ADDENDUM NO. TWO

PROJECT: Johnson County Recycling Center

PROJECT NUMBER: 23122

DATE OF ADDENDUM: May 27, 2024

4 EXTERIOR ELEVATION - EAST
SCALE: 1/8" = 1'-0" REF. 1 / A101

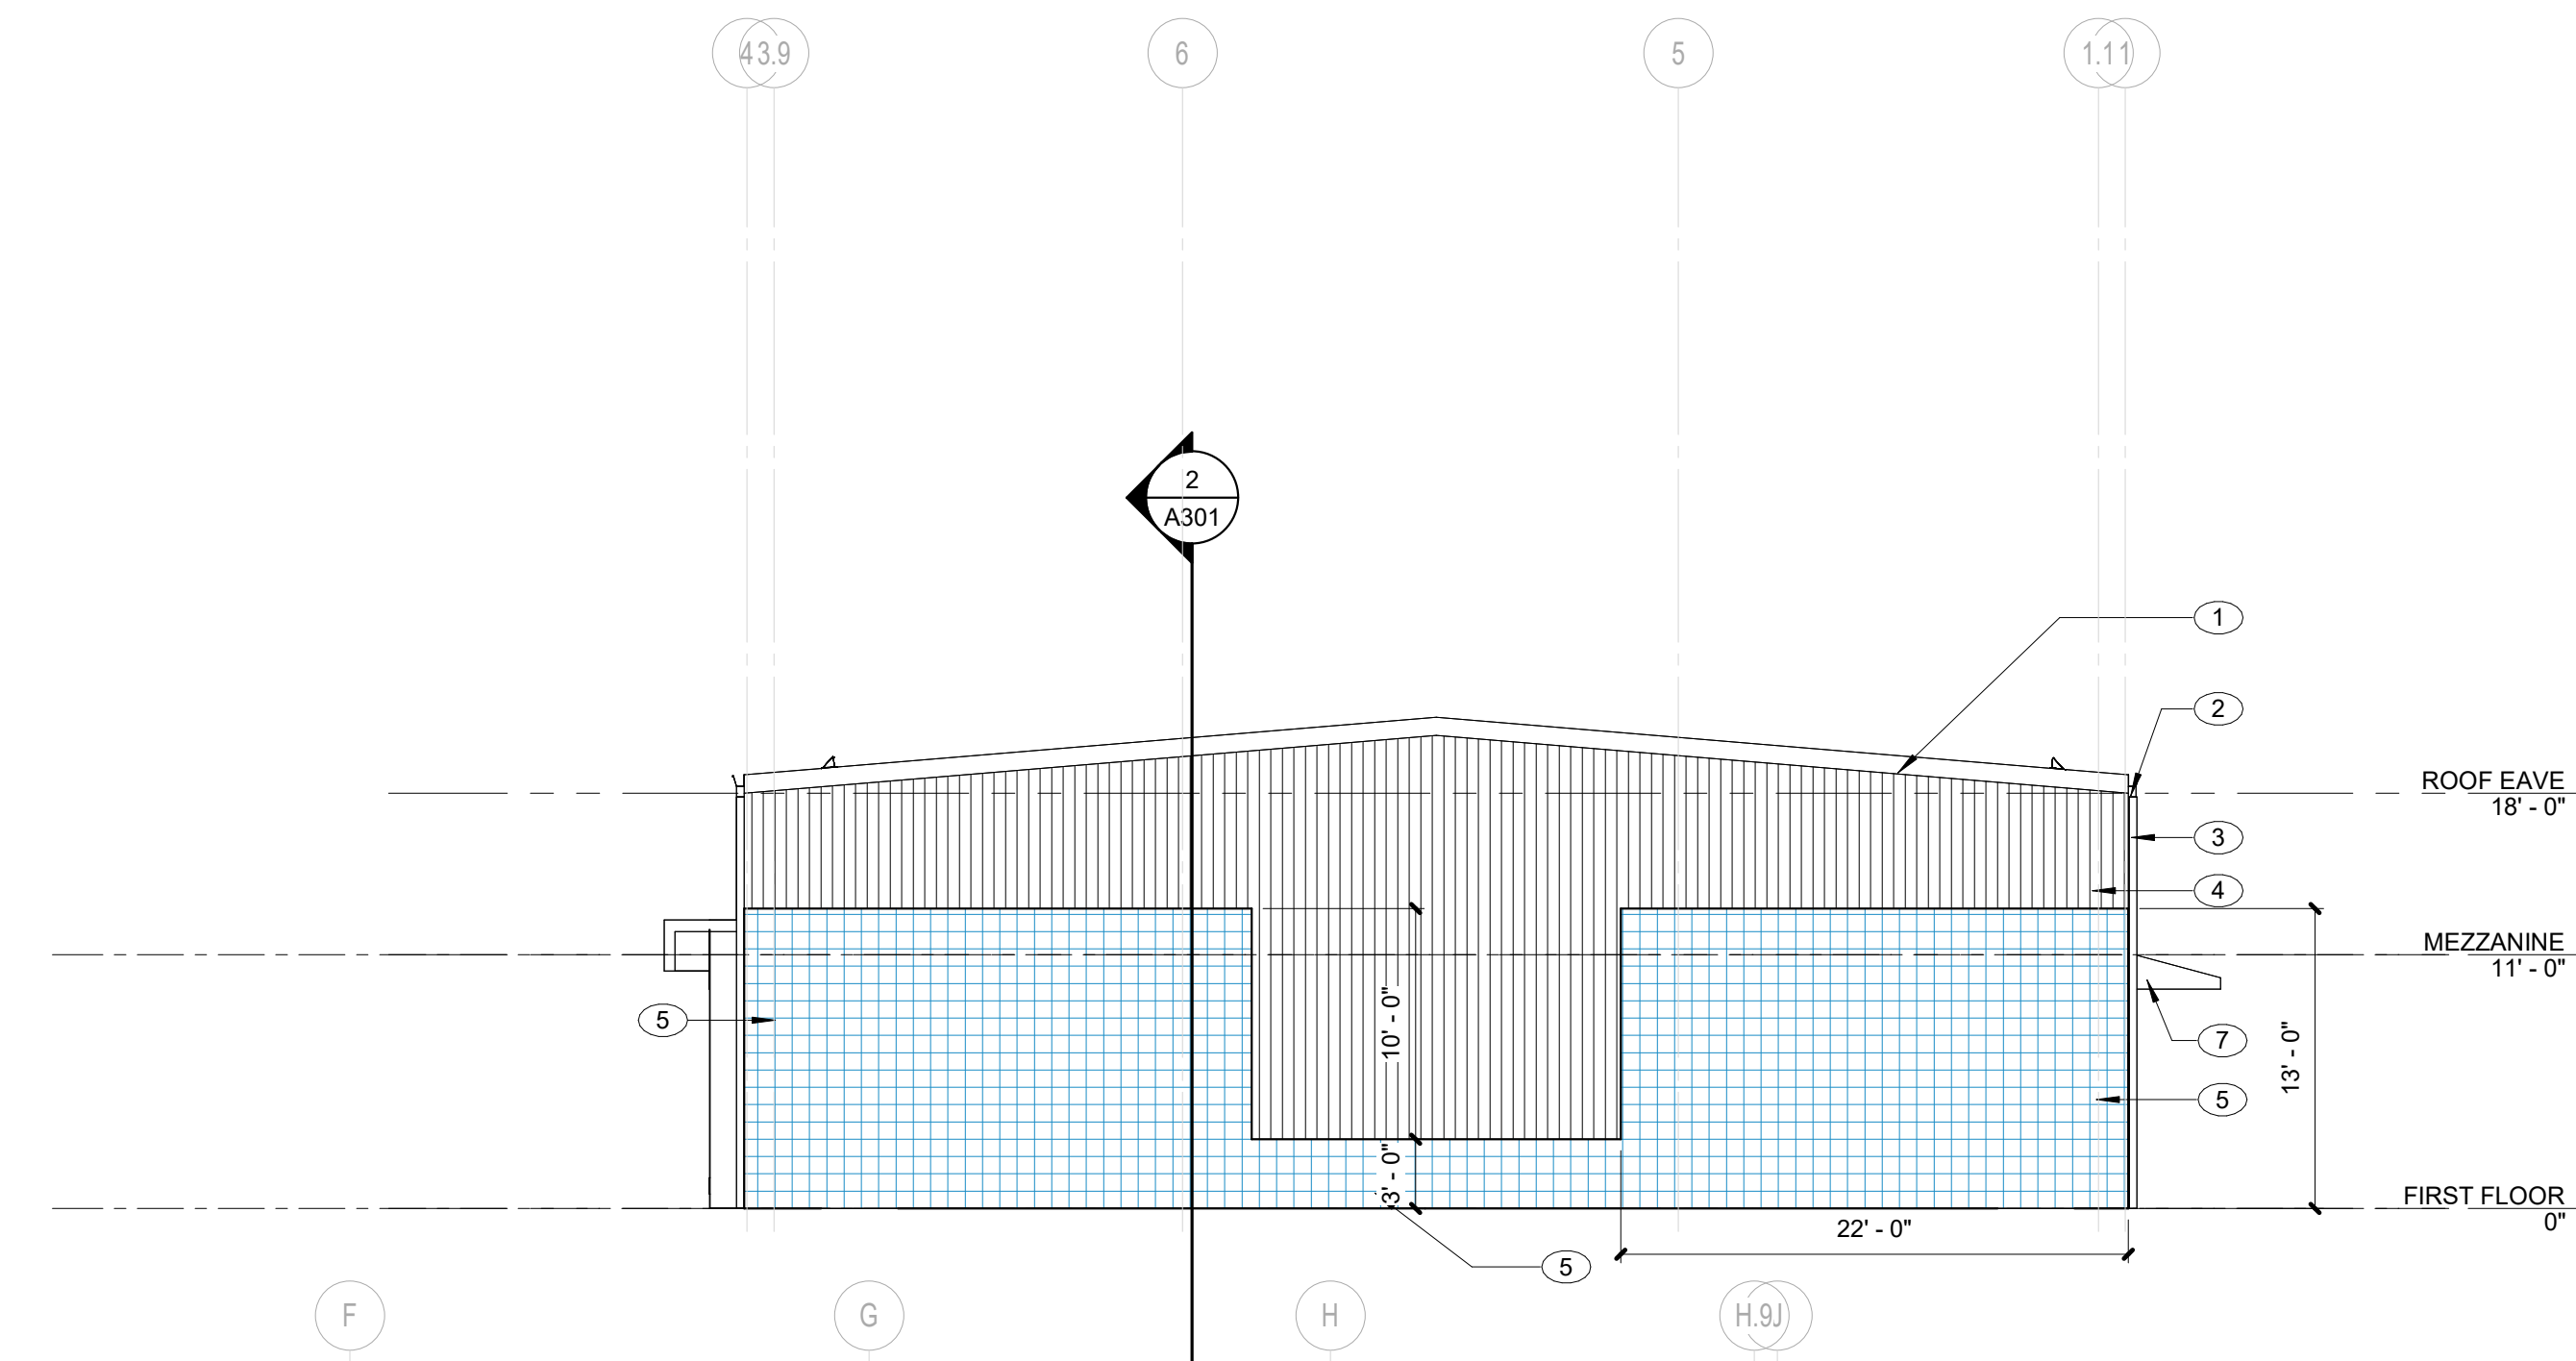
2. Drawing Number: A201
Drawing Title: EXTERIOR ELEVATIONS
Change:

Adjusted location of the downspouts on the north side
